F6 Extension Stage 1

Submissions report

Appendix B
Air quality impacts for
elevated receptors

2.0 Assessment of impacts at elevated receptors (NSW EPA)

Figure 1 RWR receptors for existing tall buildings to the north-east of the Arncliffe ventilation outlet

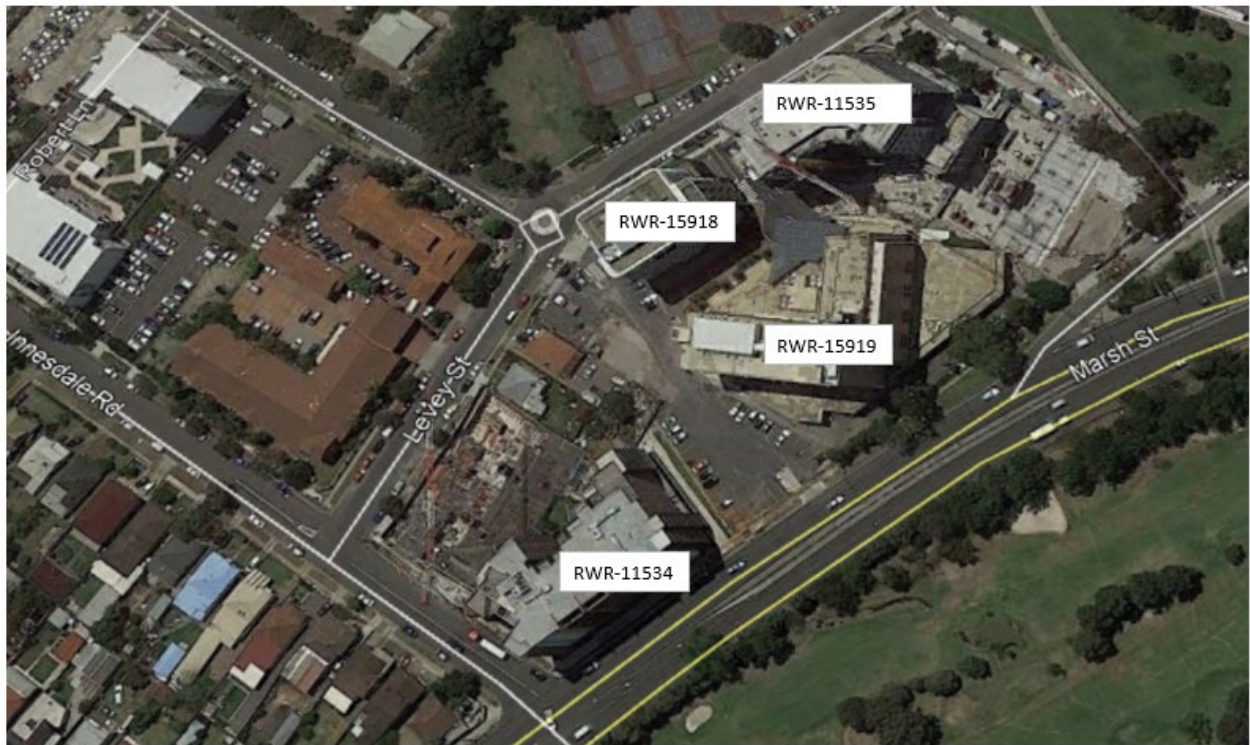
- *Confirm receptor heights located in proximity to ventilation outlets given the significant data gaps on building height described within the Air Quality Technical Report;*
- *Present predicted impacts for all pollutants and averaging periods for receptors located at height in proximity to ventilation outlets. This includes 1-hour average air toxics and for relevant pollutants accounting for background air quality;*
- *Present predicted impacts for all pollutants and averaging periods for receptors located at height in proximity to ventilation outlets, for the regulatory worst-case scenario.*

(a) Existing tall buildings in the proximity of the tunnel ventilation outlets were identified. The RWR receptors identified with these buildings are shown in **Figure 1** and **Figure 2**.

At the existing tall buildings there was, in many cases, a negative concentration increment.

Where there was predicted to be a positive concentration increment for the existing tall buildings, the largest values were generally at a height of 30 metres or 45 metres.

The results for annual mean PM_{2.5} indicate that, for all existing tall buildings near the ventilation outlets, the concentration increments at heights of up to 45 metres above ground level were well below the criterion for ΔPM_{2.5} of 1.8 µg/m³.
